Access Compliance Report Public Rights-of-Way (Curb Ramps)

Main Street: ALGERWOOD		Cross Street: DAWNWOOD		Location:	SW
ADA ID: RPRK211025120453	Ramp Type: Type 4 - Parallel	Initial Pass/Fail: Fail	Overall Compliance: No	Severity Score:	2
Codes/Mitigation Info/Possible Solution			Field Measurements/Component Compliance

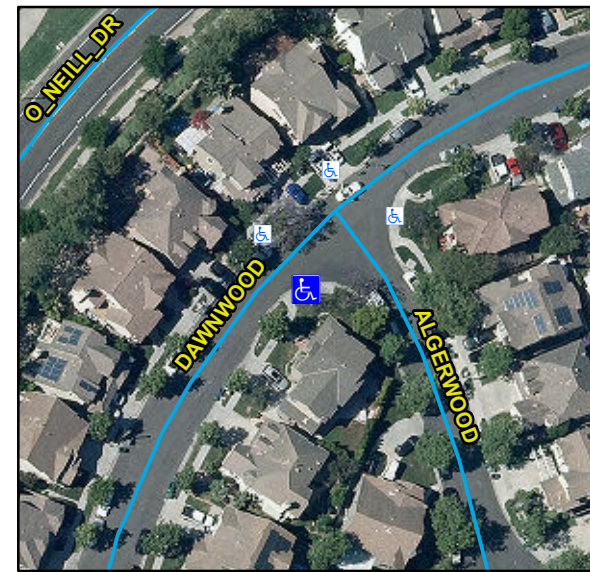
R204.3, R304.5.3, STD 1115

Compliance	Description	Data	Compliance	Description	Data
N/A	Ramp Length LT (in)	116	N/A	Ramp Length RT (in)	112
Yes	Ramp Width LT (in)	48	Yes	Ramp Width RT (in)	48
Yes	Ramp Run Slope LT (%)	5.7	Yes	Ramp Run Slope RT (%)	5.6
No	Ramp Cross Slope LT (%)	2.2	No	Ramp Cross Slope RT (%)	4.2
N/A	Landing Present	N/A	N/A	DWS Provided	N/A
N/A	Landing Length (in)	N/A	N/A	DWS Contrast	N/A
N/A	Landing Width (in)	N/A	N/A	DWS Length (in)	N/A
N/A	Landing Run Slope (%)	N/A	N/A	DWS Full Width	N/A
N/A	Landing Cross Slope (%)	N/A		DWS Offset Type	N/A
N/A	Landing Movement Obstructed?	N/A	N/A	DWS Offset Left (in)	N/A
	Landing Movement Type	N/A	N/A	DWS Offset Right (in)	N/A
N/A	Landing Shared	N/A			
N/A	Clear Space	Yes			
N/A	Clear Space To Crosswalk (in)	N/A			
N/A	Marked Crosswalk 1	No	N/A	Marked Crosswalk 2	No
	Crossing 1 Direction	NE		Crossing 2 Direction	NW
	Marked Crosswalk 1 Width (in)	N/A		Marked Crosswalk 2 Width (in)	N/A

Remove & Replace Curb Ramp With Two New Directional Ramps or Equivalent.
